Project: EDGE LANE OPENSRAW

Dwg Title: PRIVATE DRAINAGE LAYOUT

SHEET 3 of 4

Dwg No: ELL-19045-YH-B-122

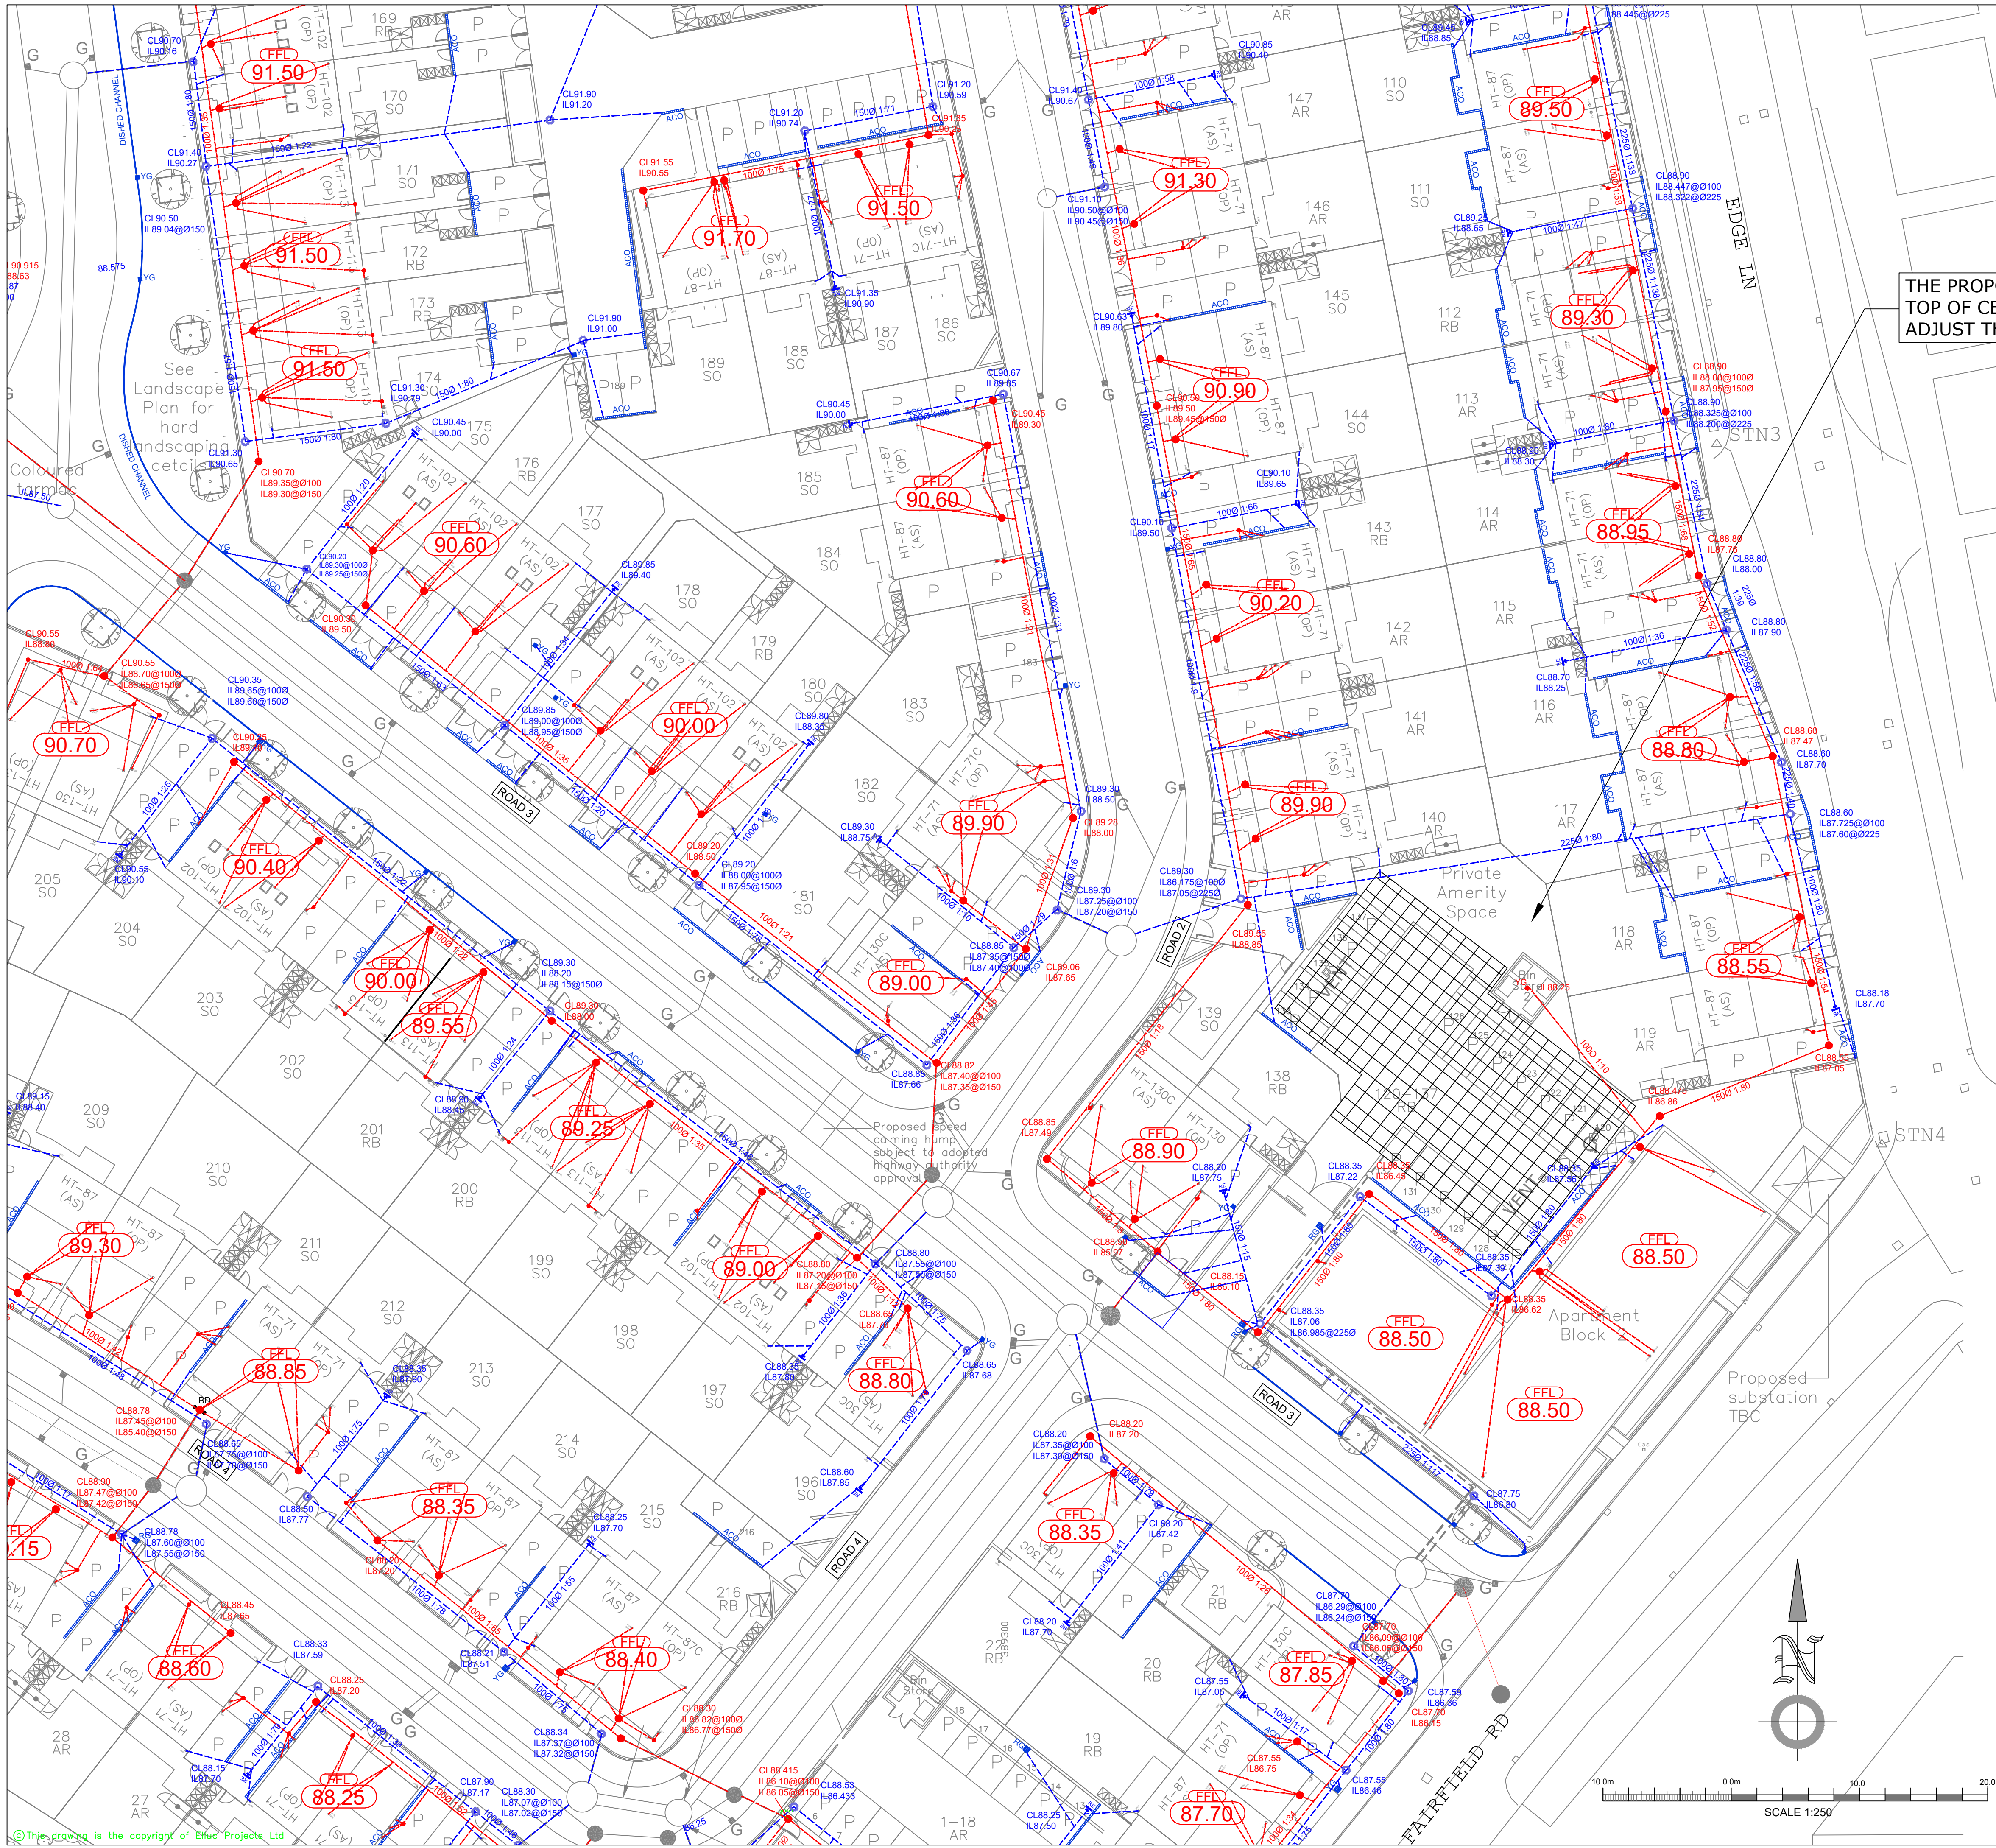
THE PROPOSED BIN STORE LOCATION IS ON TOP OF CELLULAR TANK. ARCHITECT TO ADJUST THE LOCATION AS PROPOSED.
